MORTON SOUTHWEST COMMERCIAL SUBDIVISION PRELIMINARY OVERALL AREA DEVELOPMENT PLAN									
	M.W. CUDE ENGINEERS, L.L.C. CIVIL ENGINEERS & SURVEYORS <small>LOCATION: 10325 BANDERA RD. SAN ANTONIO, TEXAS 78250 TEL: (210) 681-3951 FAX: (210) 523-7112 URL: WWW.MWCUDE.COM</small>

CITY OF SAN ANTONIO POADP APPLICATION

The City Staff Development Review Committee has reviewed Morton Southwest Commercial Subdivision Preliminary Overall Area Development Plan. Please note that your plan was not accepted, based on the following:

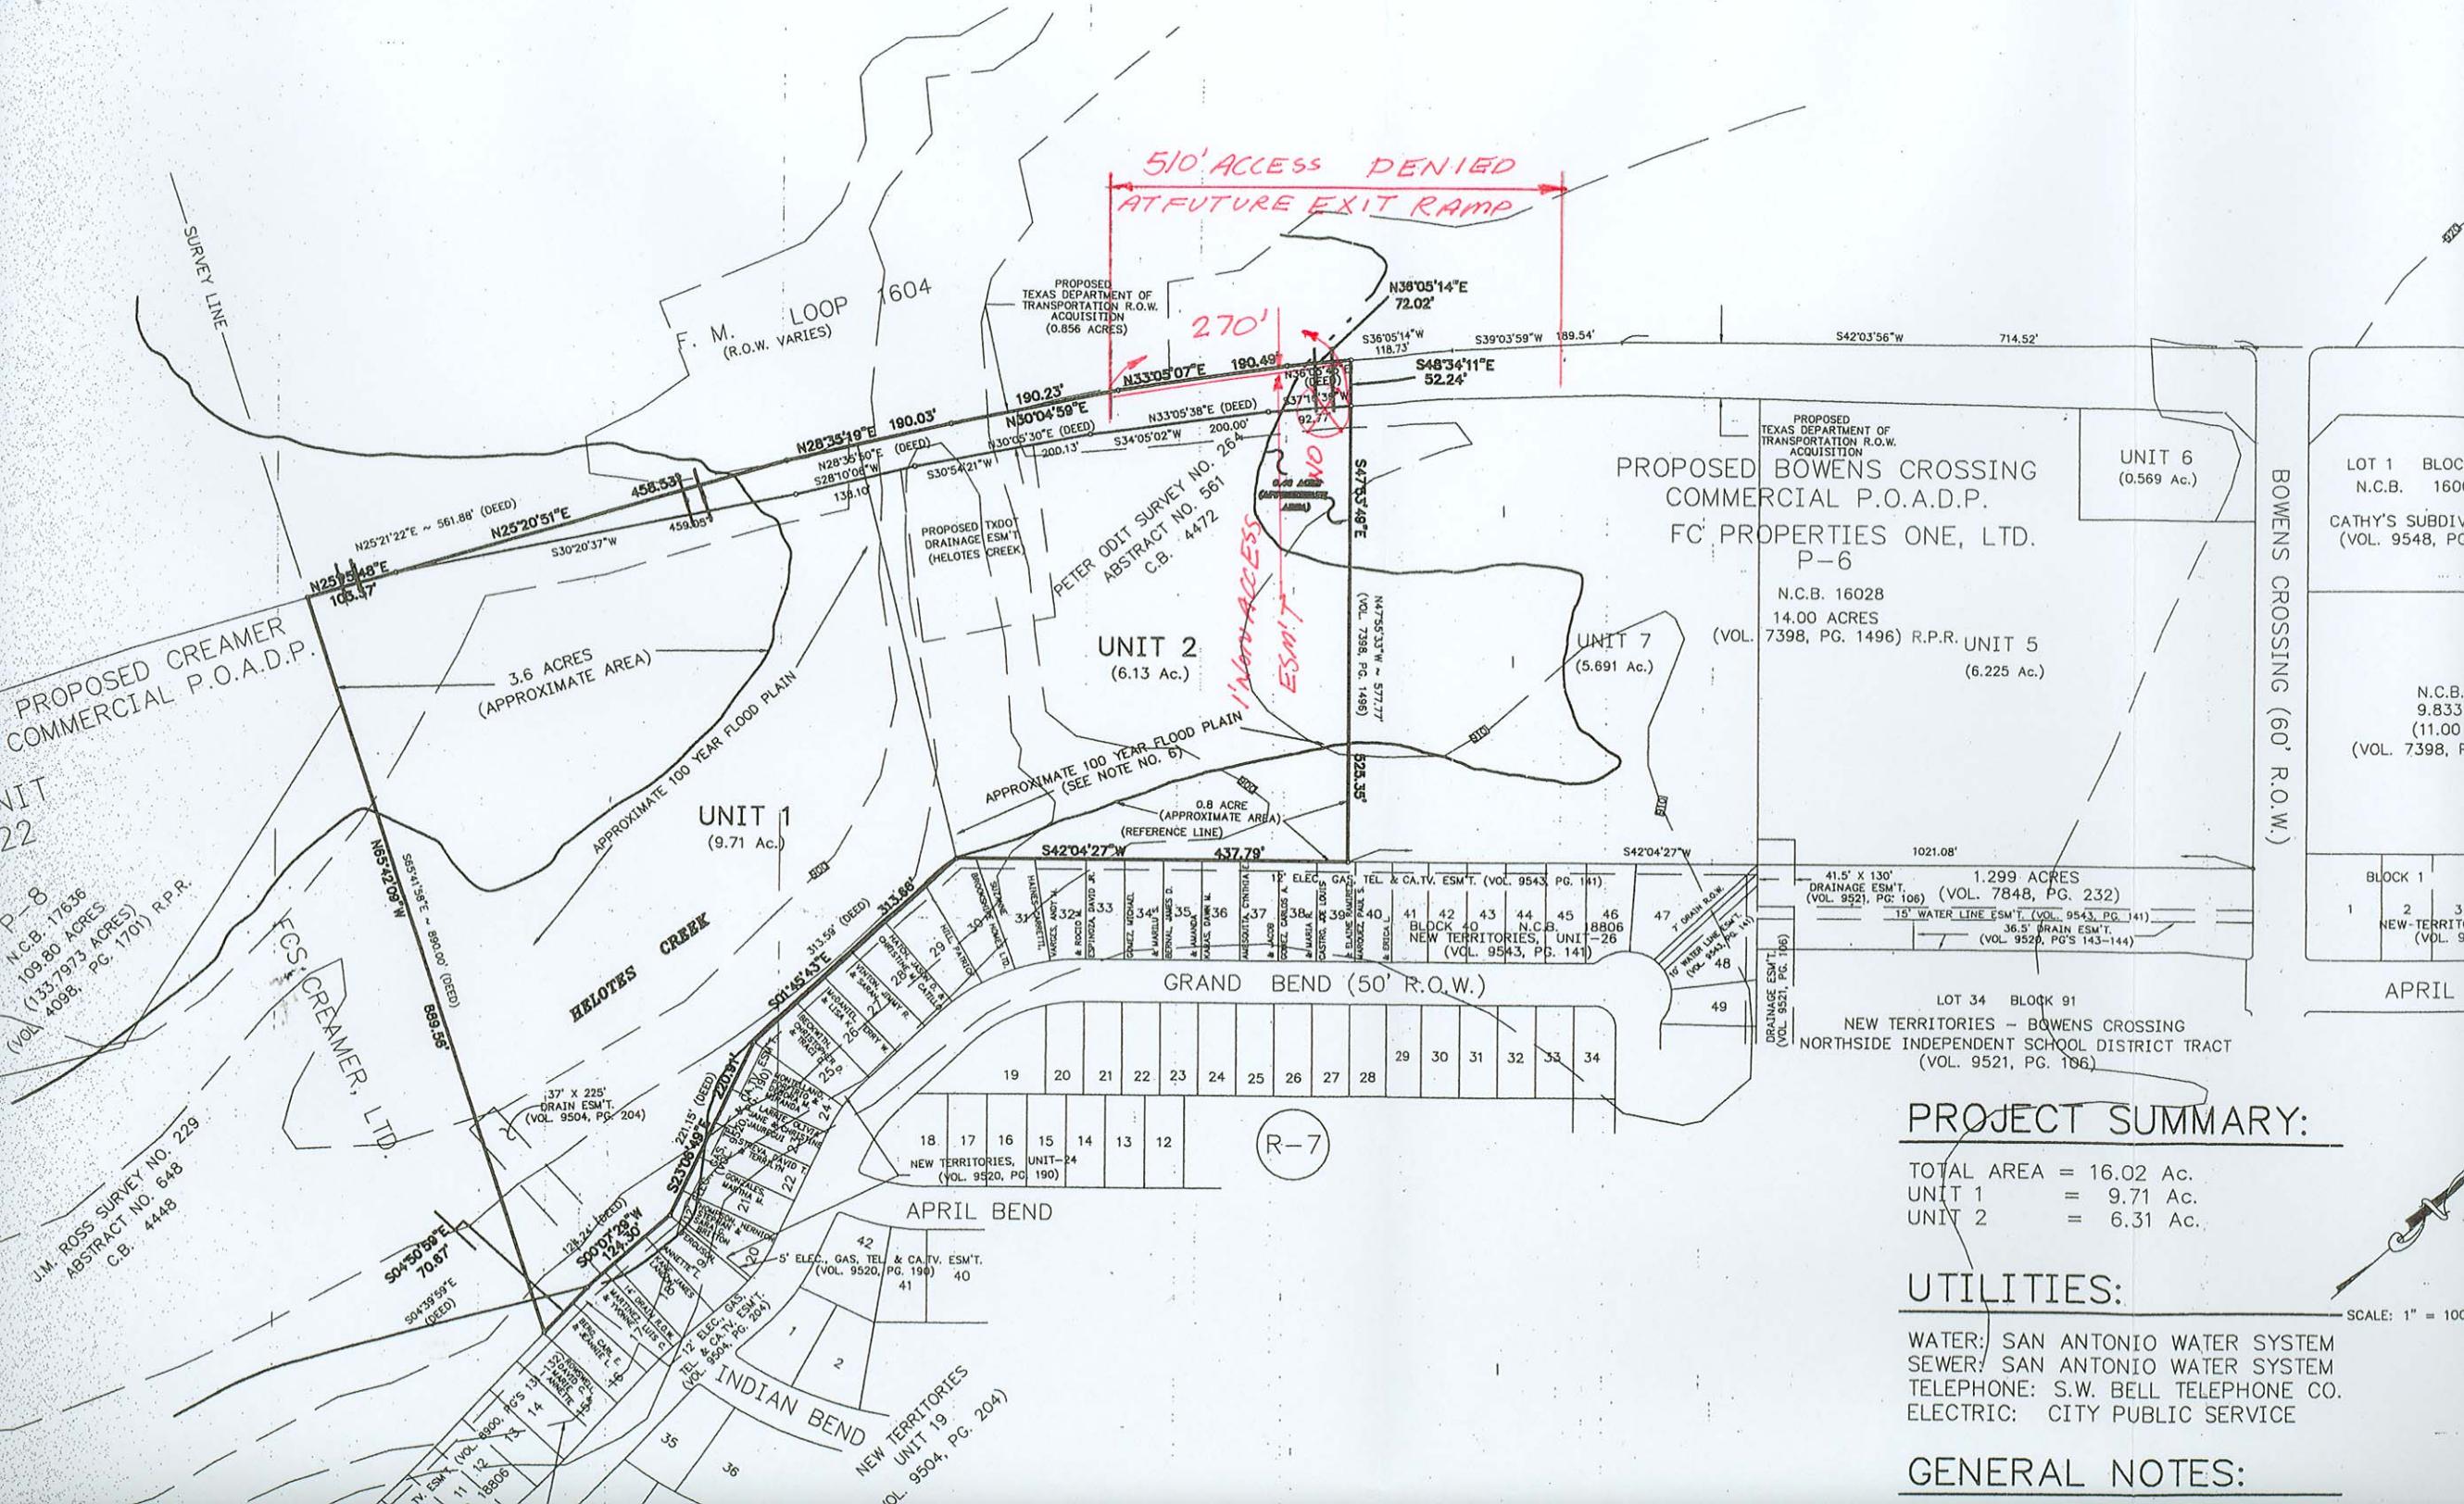
- Annotate Perimeter property lines
- Indicate any proposed POADPs adjacent to this property.
- Contour lines are missing.
- Show connectivity between proposed units.
- Annotate existing and proposed right-of-way widths on plan.
- Show existing zoning only.
- An approved T.I.A. will be required.
